# Superfund Record of Decision:

## Intel (Santa Clara III), CA

Concurrences for  
INTEL SANTA CLARA III SUPERFUND SITE  
RECORD OF DECISION

**Figure 6 Concentration of TCE vs. Time in Monitoring Well SC3-1 and Extraction Wells SC3-E1 and E2.**

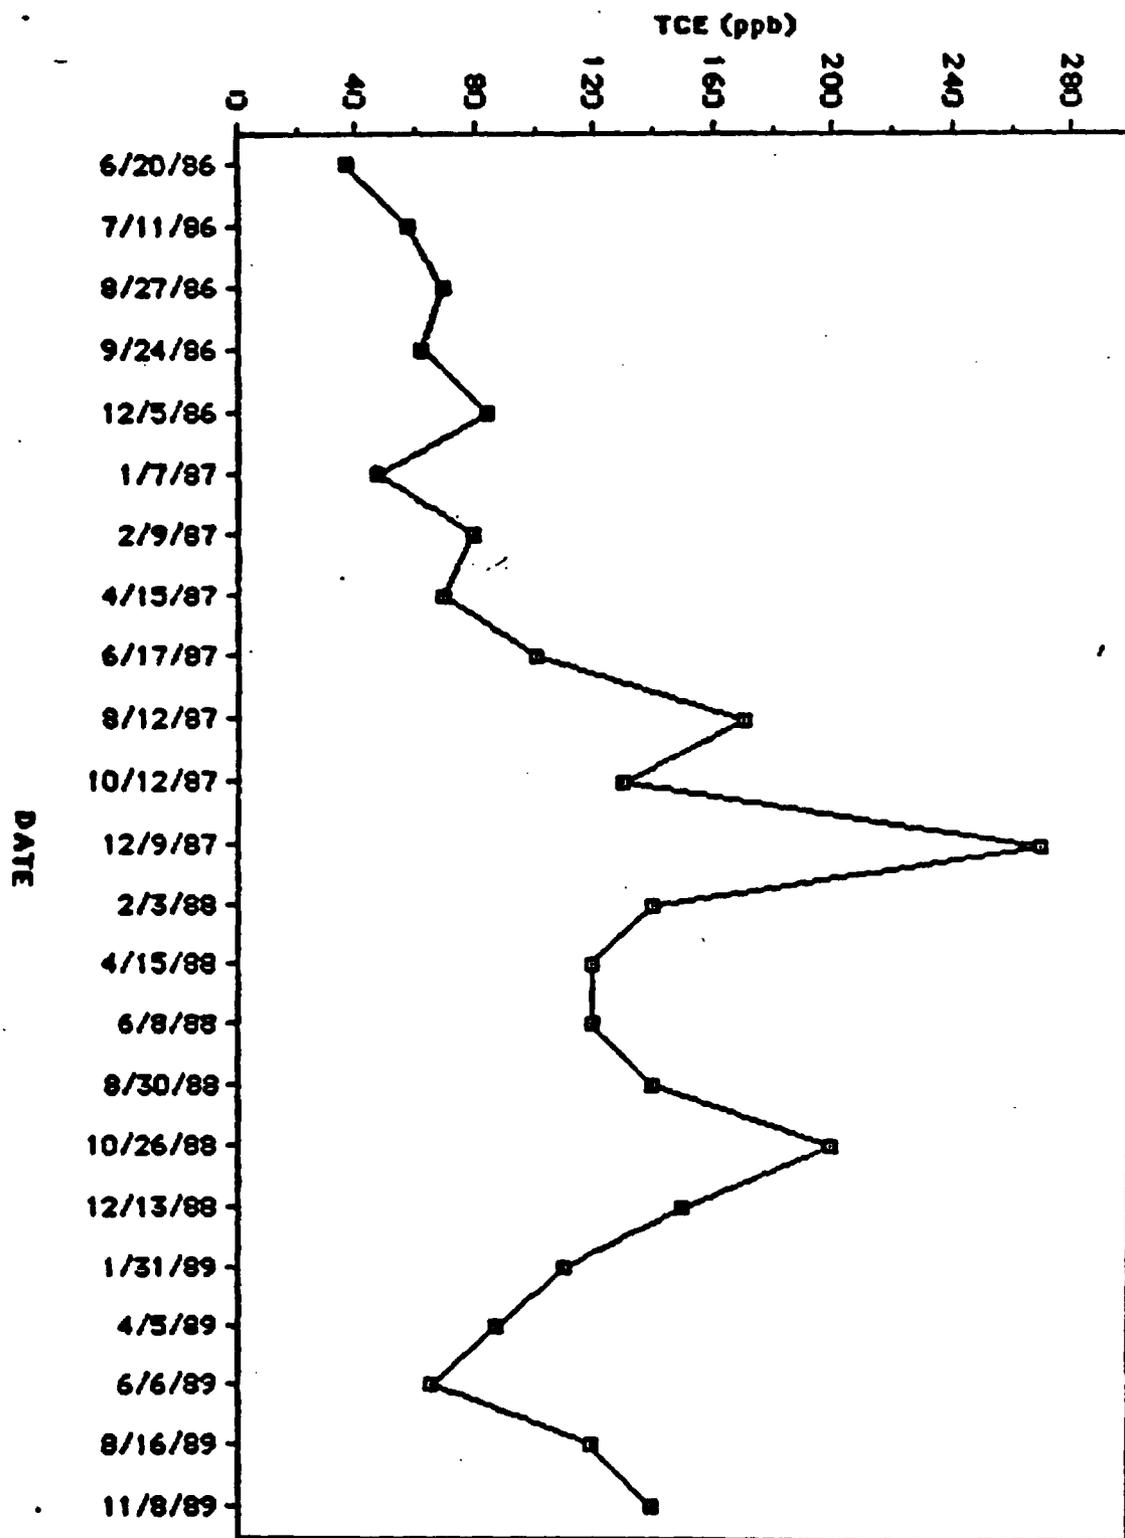
However, as shown on Figures 6 and 7 of the March 30, 1990 Staff Report (revised June 19, 1990), asymptotic levels do not appear to have been conclusively reached in all wells at SC3. With the installation of an additional extraction well and pulsed pumping, TCE levels are likely to decrease.
